Our Ref: DOC19/782608 Your Ref: SSI 7666

RE: Environmental Impact Statement - Coffs Harbour Bypass (SSI 7666)

Attachment 1: Detailed BCD Comments – Coffs Harbour Bypass (SSI 7666) – relevant NSW statutory matters

Figure 1 – example of native vegetation excluded from assessment. (Source – Figure 5.2 of BAR)

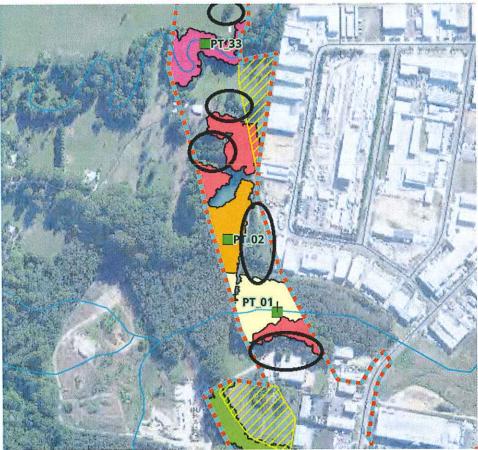
Furthermore, the mapping of the extent of native vegetation present across the development site is incomplete. Mapping appears to have excluded several areas of regrowth and/or weedy native vegetation, examples of which are illustrated below, as identified within the black polygons.

- 7. All remnants of vegetation that contain native species within the revised development site, including areas that appear to be weed-infested, must be mapped and assessed in accordance with the FBA. This is to include areas adjacent to the construction footprint, for a distance determined in consultation with the BCD either side of the development (construction) footprint.
- 8. The mapping and assessment of PCTs is to include the allocation of the appropriate PCT.
- 9. The assessor must consider that any changes to the extent and types of native vegetation identified as occurring within the development site will also likely result in changes to the extent of habitat available to threatened species and must make those changes.
